COVER SHEET
OF
FREEMAN LOGISTICS
PTNS. OF THE SE1/4, OF SEC. 17, TWP. 20 N., RGE 4 EAST, W. M.
AND PTNS. OF THE NE1/4, OF SEC. 20, TWP. 20 N., RGE 4 EAST, W. M.
PIERCE COUNTY, WASHINGTON

Title: **COVER SHEET**

FREEMAN LOGISTICS

Sheet C20 of 35

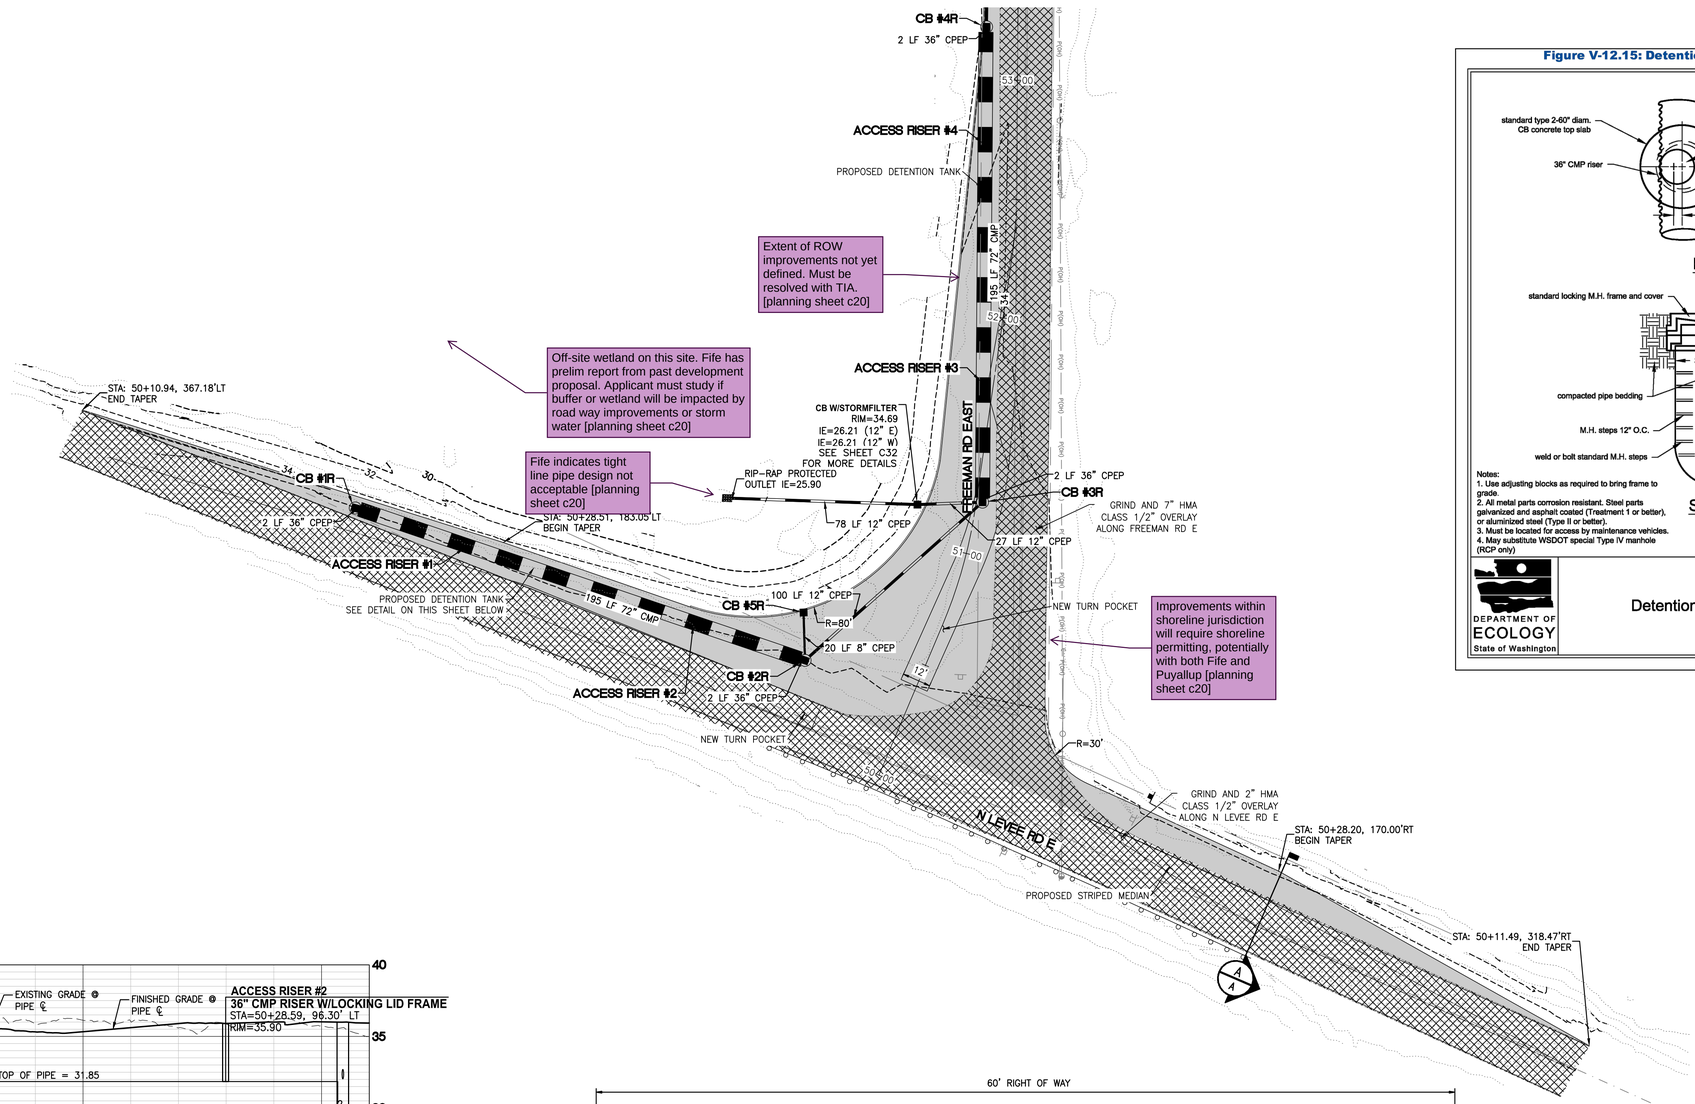
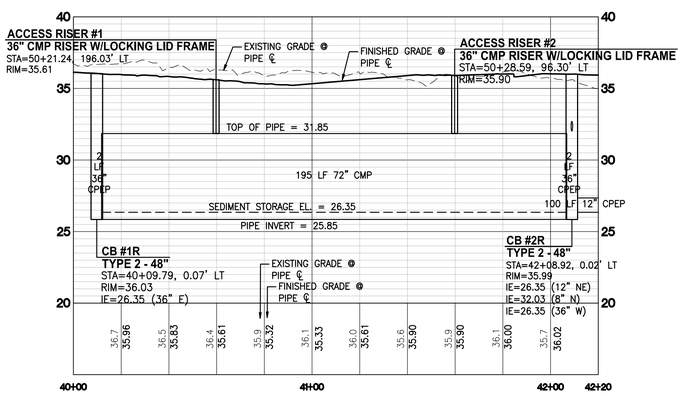
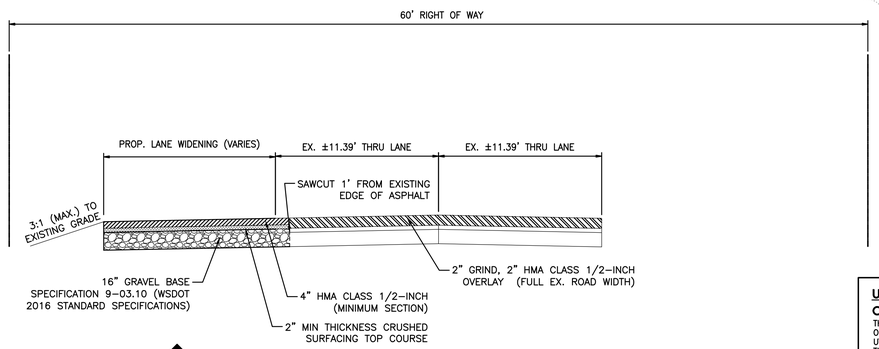
Extent of ROW improvements not yet defined. Must be resolved with TIA. [planning sheet c20]

Off-site wetland on this site. Fife has prelim report from past development proposal. Applicant must study if buffer or wetland will be impacted by road way improvements or storm water [planning sheet c20]

Fife indicates tight line pipe design not acceptable [planning sheet c20]

Improvements within shoreline jurisdiction will require shoreline permitting, potentially with both Fife and Puyallup [planning sheet c20]
